AUTOLIFT : PETERSHAM 15/5/25

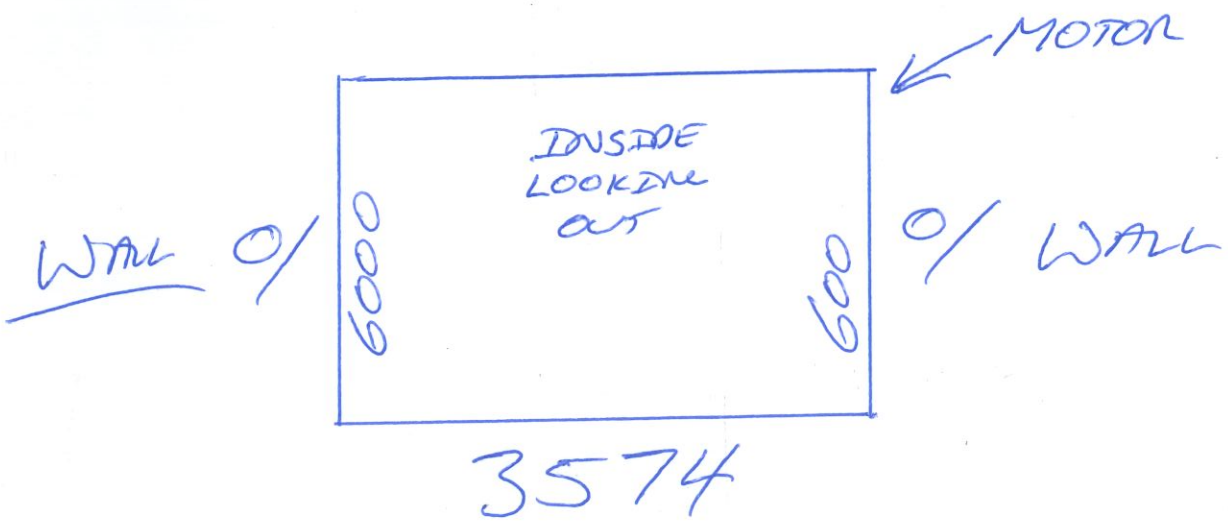
* PERF SHUTTER ON CARPARK
* MAKE SHUTTER MIN 2300MM HIGH
* P/COAT MONUMENT
* CAN YOU MAKE THE POSTS 2850 HIGH HAVE YOUR NORMAL FLOOR BRACKETS BUT LEAVE TOP SQUARE & MOUNT TO SIDE WALLS (POSTS 150X50 RHS)
* I AM PUTTING A CANOPY ON TOP
* $6,190 + GST YOUR EMAIL 17/2/25
* ADVANCE INSTALL IN APPROX 4 WEEKS DAILY TO ADVANCE INSTALLATION!!
* INSTALL 700MM FORWARD OF BEAM
